Barton St David

Parish Council

MINUTES OF THE MEETING HELD ON MONDAY 30th March 2026

AMENDED PLANNING APPLICATION 25/03038/FUL
– OFF MAIN STREET, BARTON ST DAVID, APR 2026
Erection of 22 homes together with new vehicular access,
parking and associated landscaping
28 April 2026

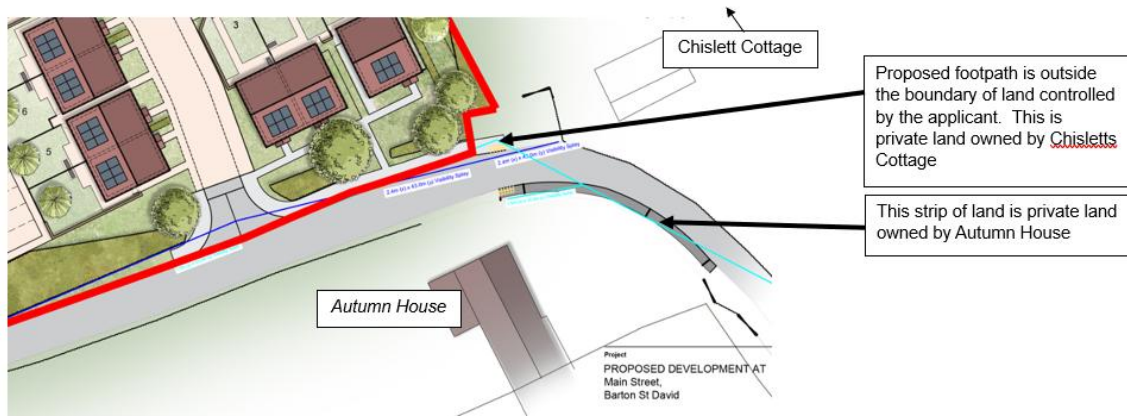
a. **The Issue.** The site's location is **not safe** for vehicles and pedestrians. The addition of a footpath will **not** mitigate the risks, and could increase safety risks to pedestrians. Therefore, National Planning Policy Framework paragraph 116 applies: *"Development should only be prevented or refused on highways grounds if there would be an unacceptable impact on highway safety"*.

- i. The new footpath on the south of Main Street does not change the facts:
 - (a) The 90-degree bend into the village, is a blind bend, only ~25m to the east

of the proposed site entrance.

(b) The bend only allows one-way traffic, with opposing traffic forced to stop and wait in both directions.

(c) Vehicles are likely to use the new footpath to pass each other around the bend, enabling 2-way traffic and increasing the risk to pedestrians. At present, large vehicles cut the bend, as evidenced by imprints in the grass verge / bank.

d. **Recommendation.** It is recommended that the Application is REFUSED as the location of the site is simply not safe for vehicular traffic and for pedestrian use by the residents of the proposed site – contrary to NPPF Paragraphs 109, 115, 116, 117. There are alternative, safer potential development sites in the village identified in Somerset Council's SSDC Housing and Employment Land Availability Assessment 2017, Review August 2021, and in Barton St David's draft Neighbourhood Plan.

c. **Land Ownership.**

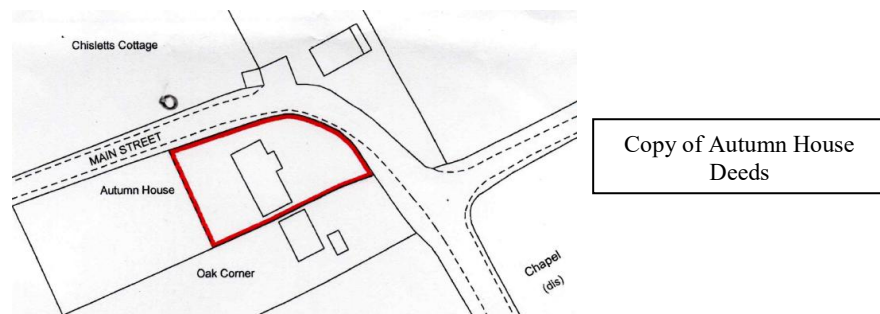
i. Title Deeds show that the land on which the Applicant proposes to build the new footpath is owned by Autumn House.^{2, 3}

ii. The eastern end of the proposed footpath on the north of Main Street also encroaches onto land owned by Chislett Cottage.
